SUBJECT: Docket No. 50-602, Response to Request for Additional Information on
(Transportation) Quality Assurance Plan

REFERENCE: Request for Additional information for Review and approval of the University of
Texas at Austin Request for Part 71 Quality Assurance Program for Packaging and
Transportation of Radioactive Material (September 26, 2018 – ADAMS accession
number ML18270A082)

RESPONSE TO ADDITIONAL INFORMATION OF SEP 26 1018

UT Austin Nuclear Engineering Teaching Laboratory QUALITY ASSURANCE PROGRAM (TYPE B PACKAGES)

Figure 1

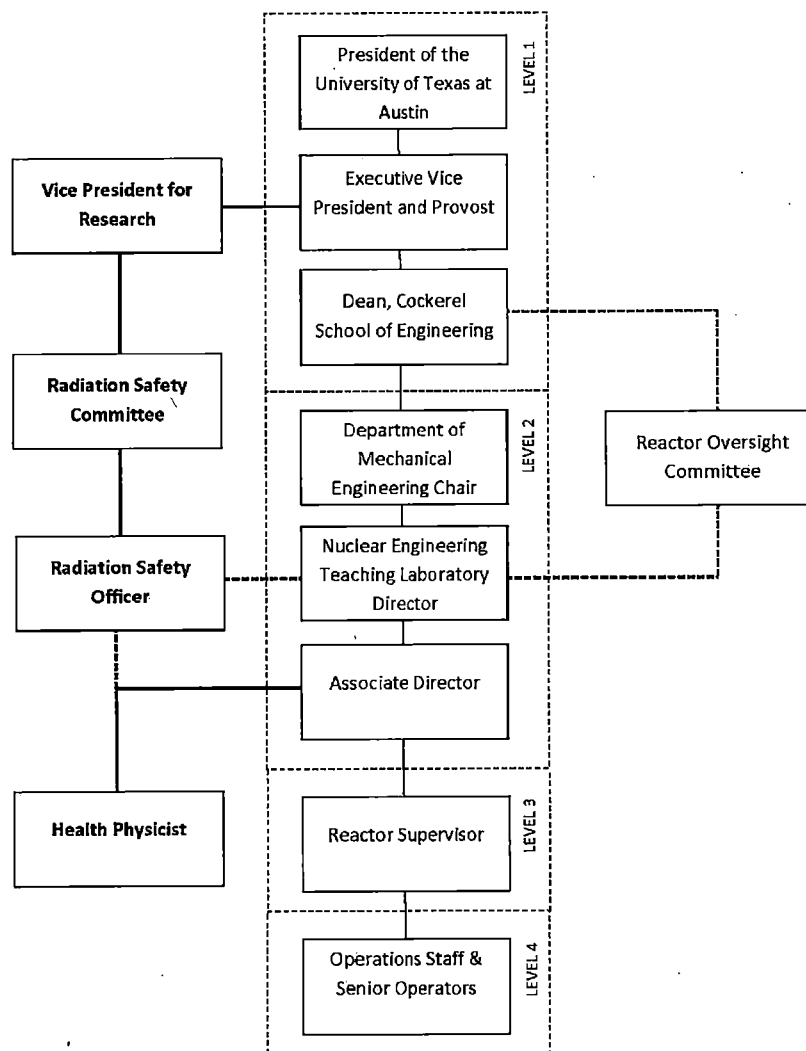
1. Provide a description of how the current organization provides assurance that the required authority and organizational freedom, including sufficient independence from cost and schedule, when opposed to safety considerations, are provided.

Under the current organization chart and organization description it appears that the QAP and NETL daily operations will be performed within the operating organization. In addition, it appears that the staff performing the packaging, shipping and receiving inspections will also be responsible for implementing the QAP.

This information is needed to determine compliance with 10 CFR 71.103(d).

As is typical with university research reactor facilities, NETL has a small staff. As a result, the NETL staff members regularly perform multiple types of duties. Thus, during an operation involving packaging material that falls under this QAP, NETL operations staff would also perform QA activities. We do not feel this is a conflict of interest since when operating within a "nuclear safety culture," ALL members of the organization have authority and responsibility to report safety related issues. Certain NETL operations and supervisory staff are licensed by the US Nuclear Regulatory Commission and have legal responsibilities to "observe, all applicable rules, regulations, and orders of the Commission" (10CFR55.53(d)) with protection from potential retaliation (10CFR50.7) and all university staff have the authority to report suspected noncompliance or safety issues and are protected from potential retaliation (UT-System policy UTS 131). Furthermore, should a NETL staff member feel their concern is not being addressed within NETL, they can report via the Compliance & Ethics Hotline (<https://compliance.utexas.edu/>, <https://www.utsystem.edu/offices/systemwide-compliance/hotline>, 877-507-7321) to the University Compliance Services where the matter will be escalated to university upper management with protection from potential retaliation (UT Handbook of Operating Procedures 3-1022). In addition, the Reactor Oversight Committee reviews the QAP and the results of activities conducted under the QAP.
